MEMORANDUM

SUBJECT NO. 1: **Preliminary Forest Conservation Plan: Mandatory Referral No. 07203-MCPS-1: Luxmanor Elementary School Addition – 6201 Tilden Lane, R-200 Zone, North Bethesda Master Plan**

SUBJECT NO. 2: **Mandatory Referral No. 07203-MCPS-1: Luxmanor Elementary School Addition – 6201 Tilden Lane, R-200 Zone, North Bethesda Master Plan**

Proposed Site Plan

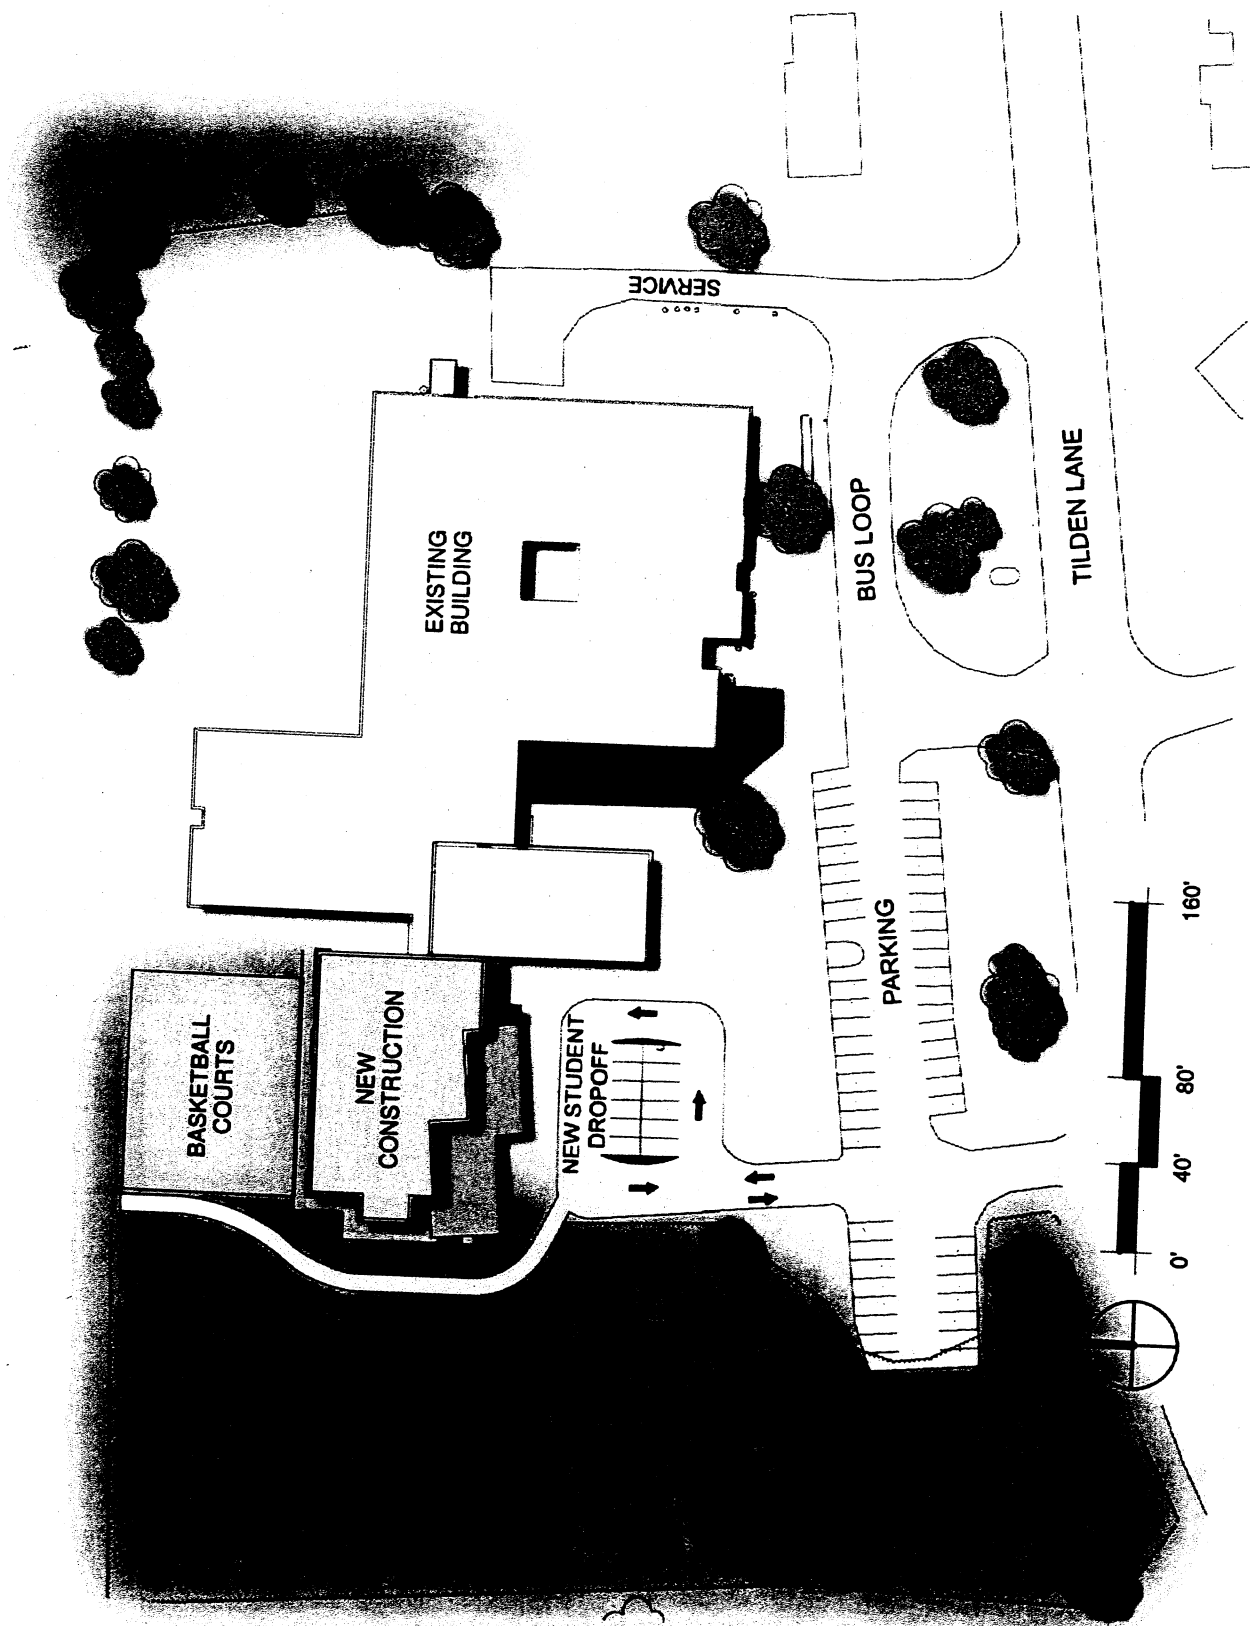
1. Install crosswalk markings at all entrances along Tilden Lane and provide lead-in sidewalks from Tilden Lane along the eastern side of the new student drop-off area and extend the western sidewalk at the main entrance.
2. Provide evergreen shrubs to screen existing surface parking along Tilden Lane.
3. The applicant must obtain a sediment control permit from the Department of Permitting Services.
4. The applicant must obtain a final stormwater management approval from the Department of Permitting Services.

Tilden Lane is the only access to the property. All teacher parking, and drop-off and pick-up areas occur in the front of the school. These access points will be retained with the proposed expansion. The western access lane will be expanded to 36 feet to accommodate right and left turn movements from the new student drop-off area.

Twelve new parking spaces will be added to the existing 51 spaces. Existing basketball courts will be converted into a new student drop-off with twelve parking spaces. All existing parking will remain. Staff recommends the installation of evergreen shrubs to screen existing surface parking along Tilden Lane.

1. MCPS must provide a Local Area Transportation Review (LATR) study if future improvements at the school would increase school's core capacity, which will be at 429 students with the current additions/renovations.
2. MCPS must investigate the feasibility of constructing the following additional lead-in sidewalks to Tilden Lane as part of this mandatory referral to enhance pedestrian accessibility to the school:

- a. Along the east side of the westernmost driveway, and
 - b. Along the west side of the center driveway.
3. MCPS must address the following items in the next facility planning study for the school:
- a. Prohibition of parent drop-off and pick-up of students along Tilden Lane and other neighboring streets, and provision for adequate accommodation of all parent vehicles and student buses on campus.
 - b. Construction of the section of the master-planned Tilden Lane-Executive Boulevard Bikeway Connector along the eastern edge of the school property and the park property as a paved Class I shared use path, working in coordination with M-NCPPC Department of Parks.
